I am writing on behalf of CARE Suffolk regarding the Statutory Consultation for the Bramford to Twinstead reinforcement proposal.

Overgrounding at the Bramford end of the proposal and impact on human and wildlife health

The below map shows the solar farms and battery storage mentioned.

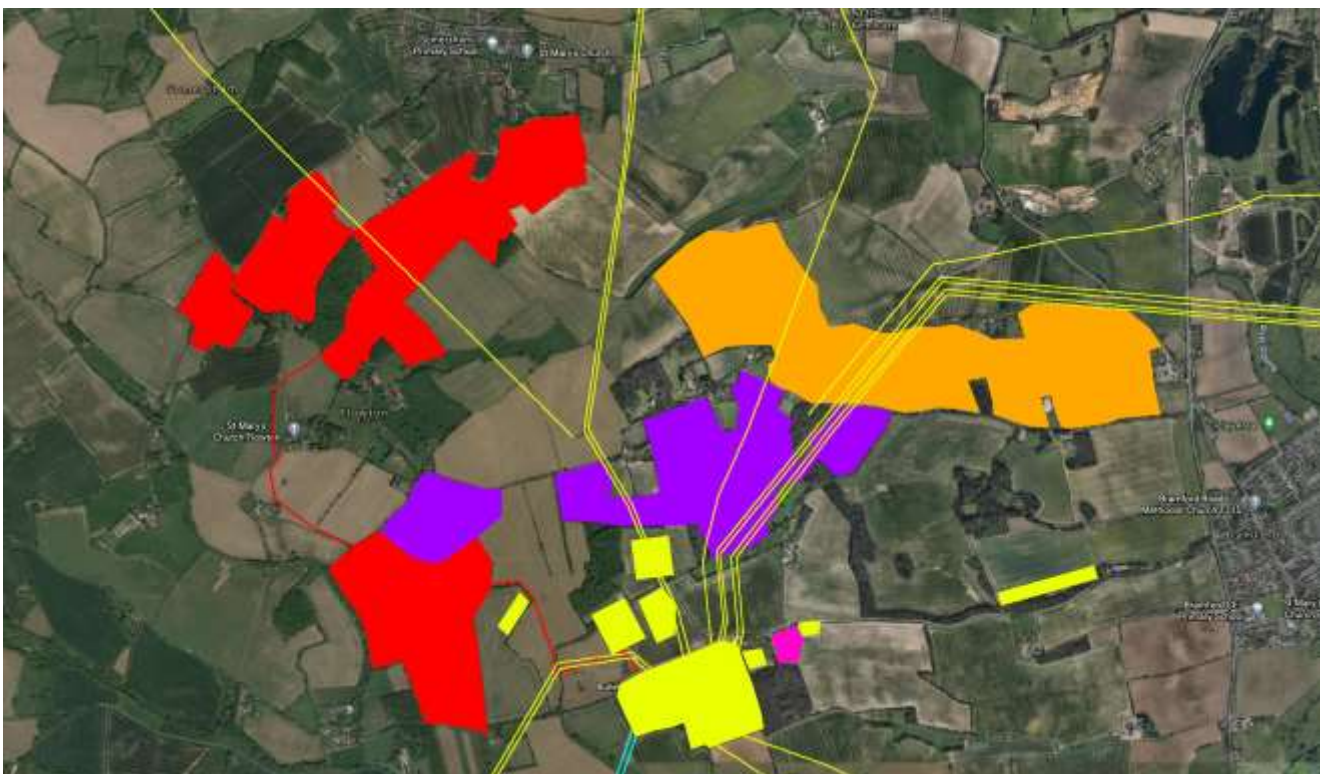
Appendix 15.3 for DC/20/05895, DC/21/00060 and DC/21/02958 are all solar farms, and the conclusion is that the proximity of these to the proposed development would result in cumulative impacts, particularly on landscape and visual. DC/21/04711, also for a solar farm and in such close proximity, would also have cumulative impacts. The close proximity of DC/21/05468 also gives rise to potential cumulative impacts.

The combination of these proposed developments would give rise to a significantly changed landscape alongside the proposed development of the Bramford to Twinstead line. We note that the cabling for the EA1 project was fully underground, with the mitigation on the landscape being a key factor for this decision.
